ADDENDUM #2

Reference: Building 5030 Dining Hall Remodel/Addition – Camp Williams
Utah National Guard – Riverton, Utah
DFCM Project No. 06296480

ADDENDUM #2

Utah National Guard
Bldg. 503 Mess Hall
Camp W.G. Williams, Utah

L1 ROOF POWER PLAN
 SCALE: 3/16"=1'-0"

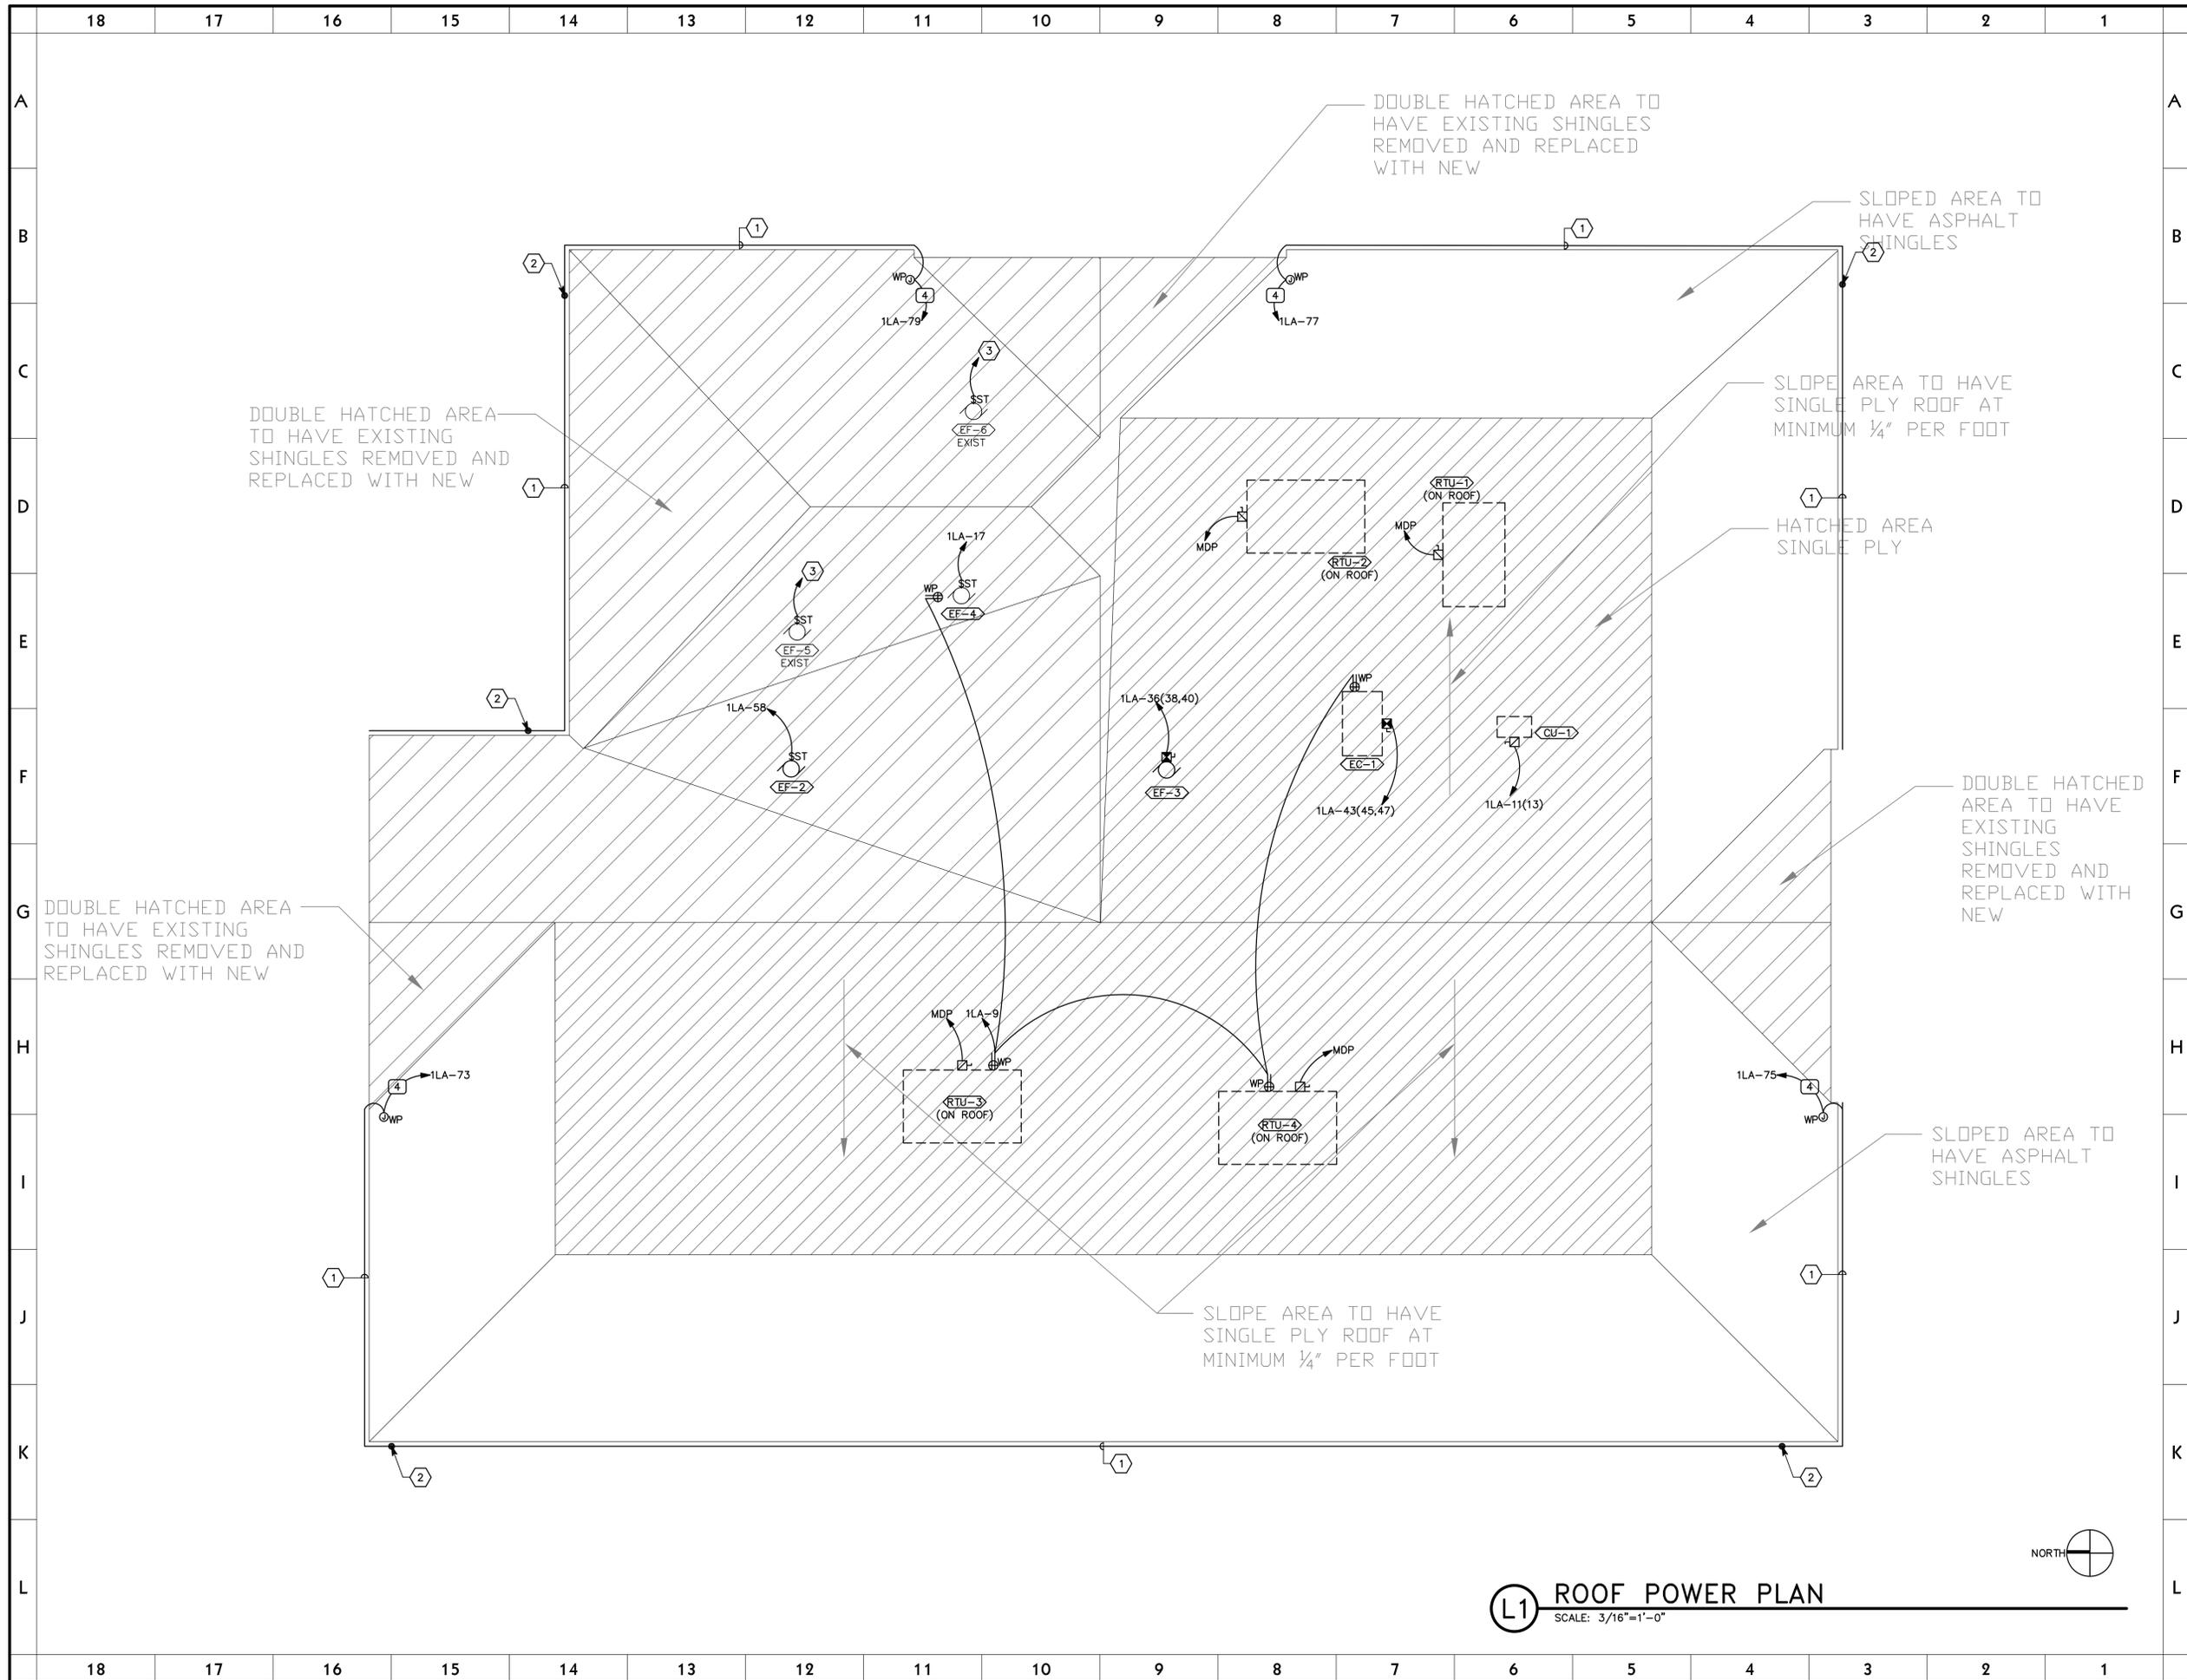
19. New sheet added.
20. Rooftop equipment shown on the roof. Verify all newly shown and previously shown mechanical equipment and connection requirements. Various mechanical units have been modified/added.
21. Heat trace ice melt added in roof gutters and downspouts.

L1 FIRE ALARM PLAN
 SCALE: 3/16"=1'-0"

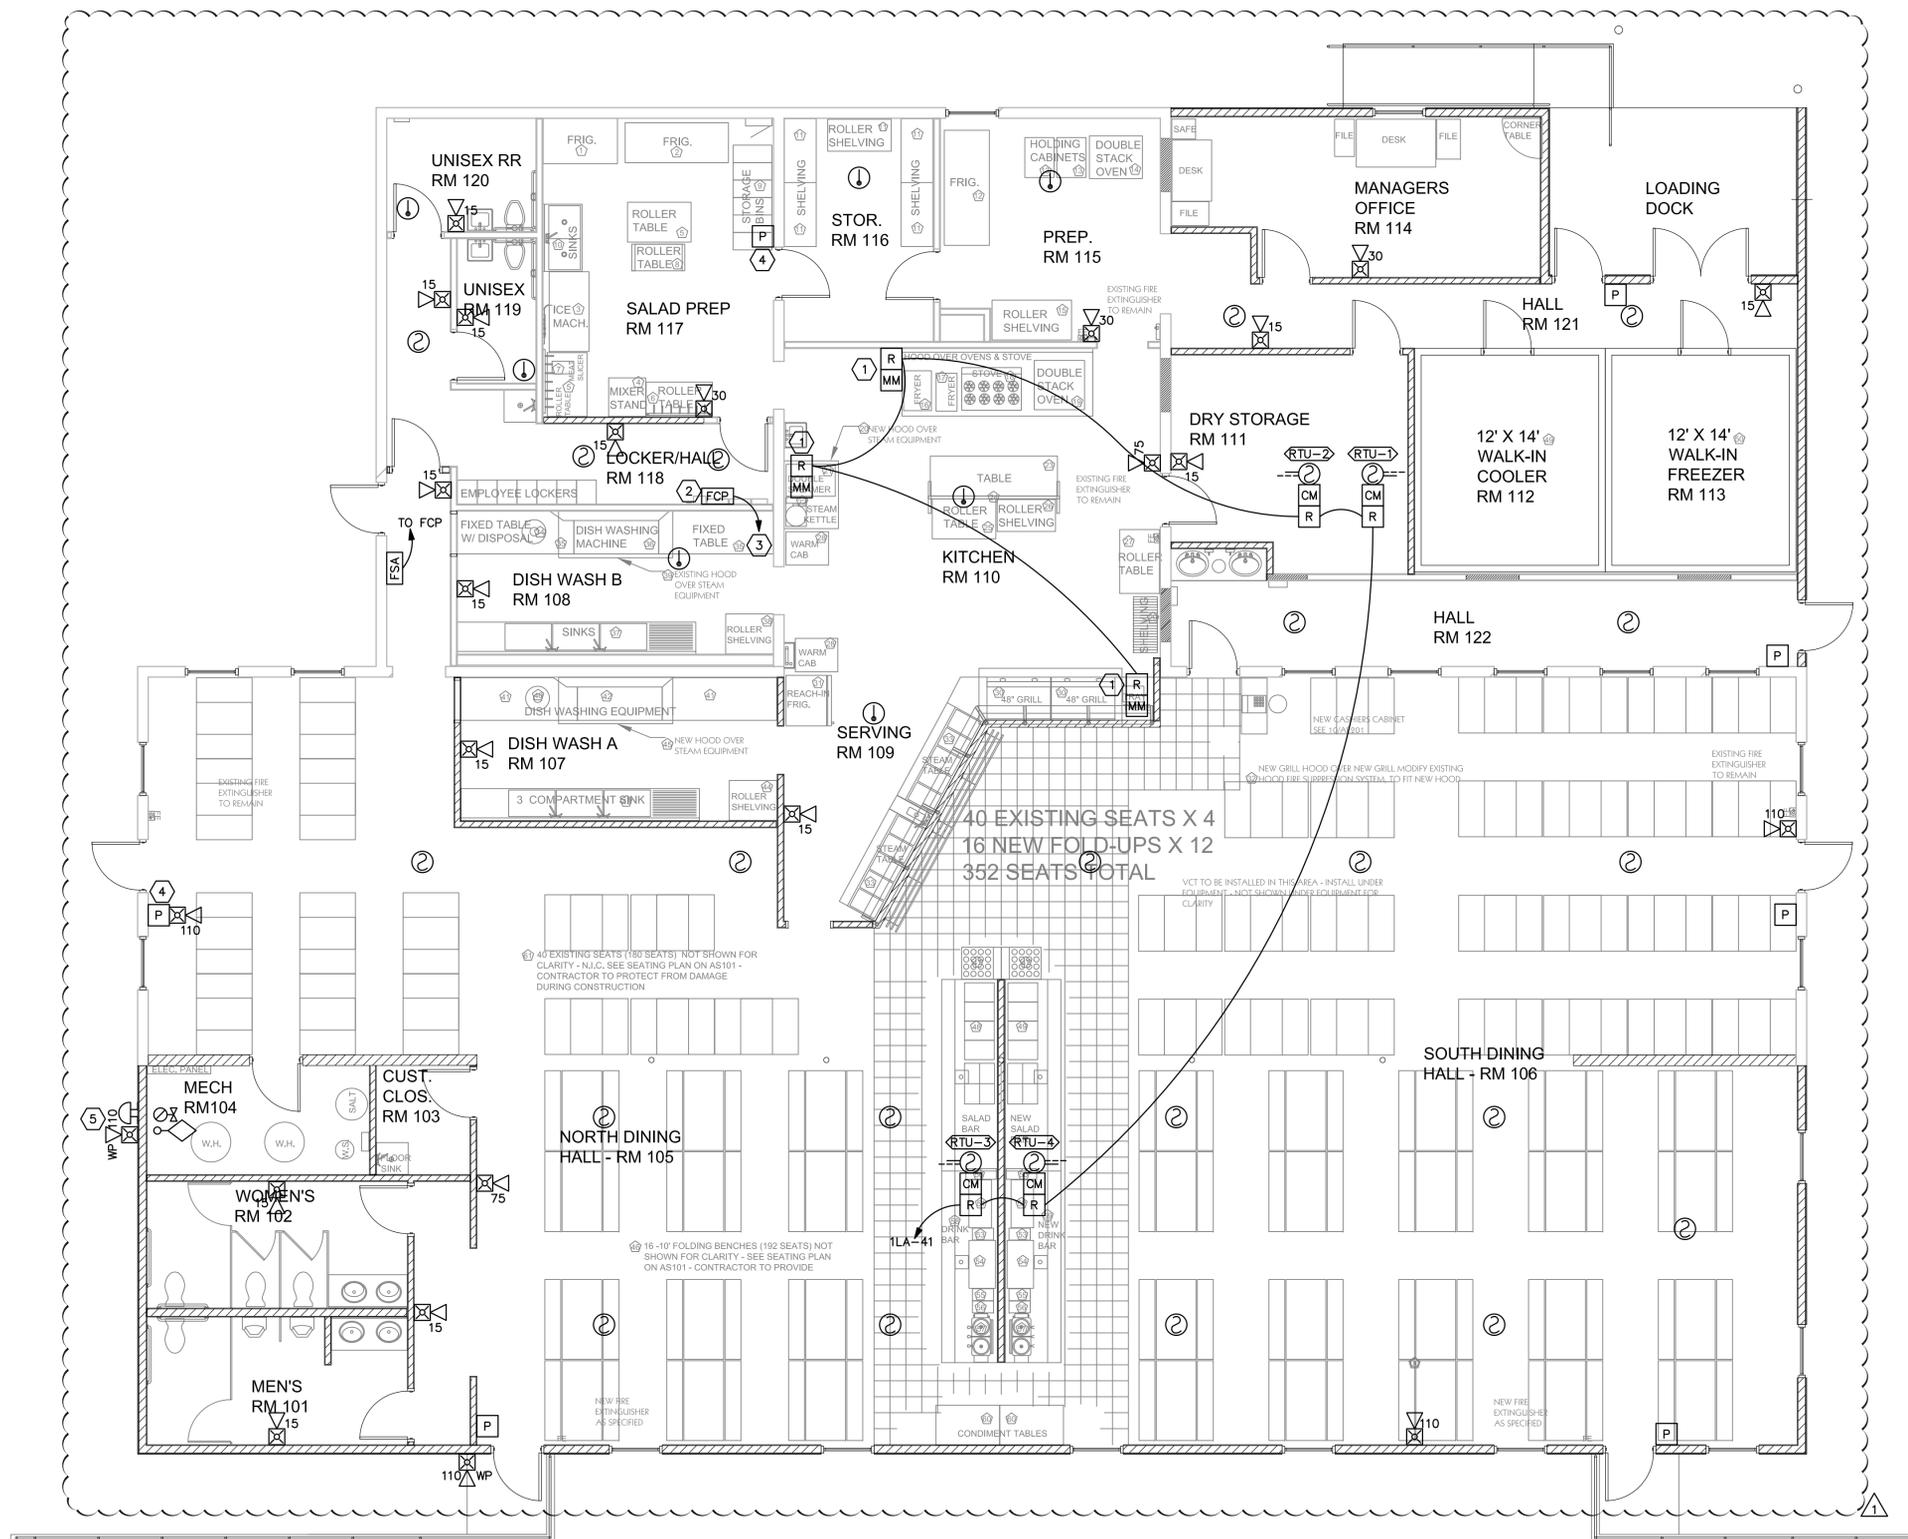
26. Fire alarm system to be all new addressable system. The new system shall be monitored by the fire alarm system at the Guard Shack (Simplex panel).
27. Contractor shall be responsible for connection wiring to Guard Shack fire alarm panel. Field verify requirements prior to bid.
